Subject: Resolution Conditions Review
1 Godwin Ave., LLC
Sola Salon
1 Godwin Ave.
Block 3, Lot 24.01
LAN Ref. #2.2428.257

LAN Associates Engineering, Planning, Architecture, Surveying, Inc. (LAN) is in receipt of a revised site plan set last revised 11/05/21. The following is our review of those revised plans with respect to compliance with the approved resolution.

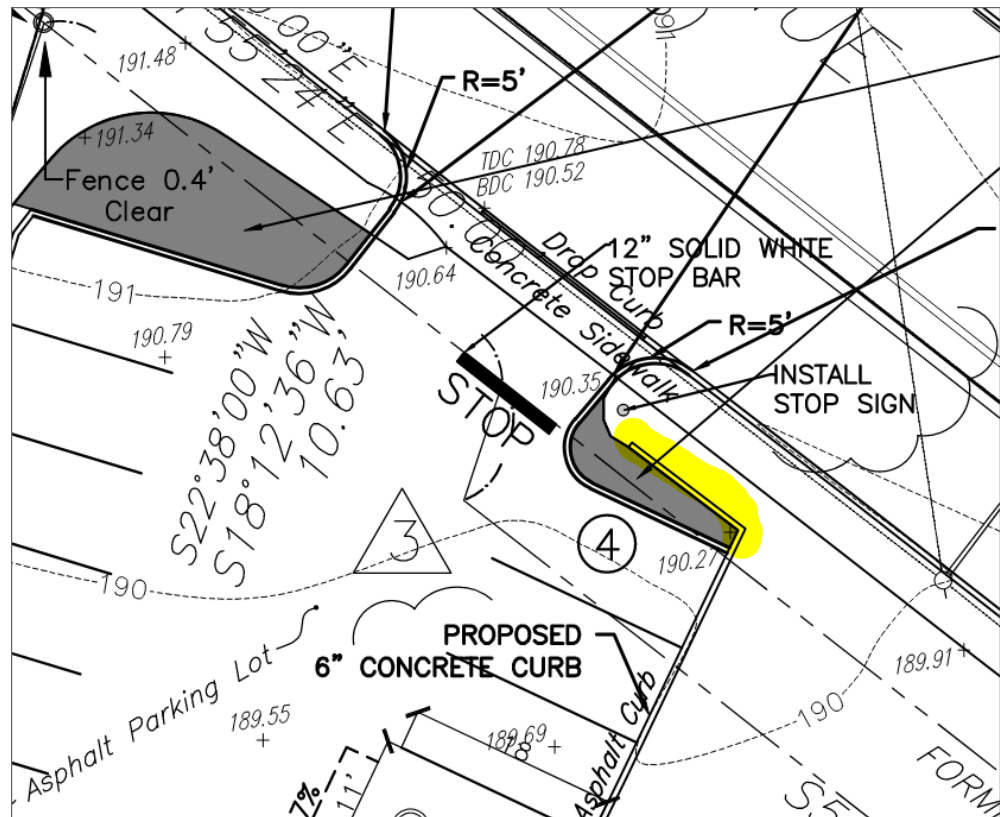
- **The sidewalks along Cottage Street are indicated to be 4' wide sidewalks, 2' from the curb. The plans should be revised to show this configuration, as only the far side of the sidewalk is currently shown, and the proposed 2' grass strip is not shown. Notes or a construction detail should be added to the plans indicating the depth of topsoil and planting specifications for grass in the new 2' grass strip.**

- The Godwin Ave. driveway has been reconfigured with new curbing. The old, (highlighted) curb section should be removed as part of this reconfiguration. Furthermore, the existing drop curb as shown does not align with the new curbing. This should be rectified.

The plans should be revised to address this comment.

The plans should be revised to address the highlighted curb to be removed. The previously mentioned depressed curb has been revised as suggested.
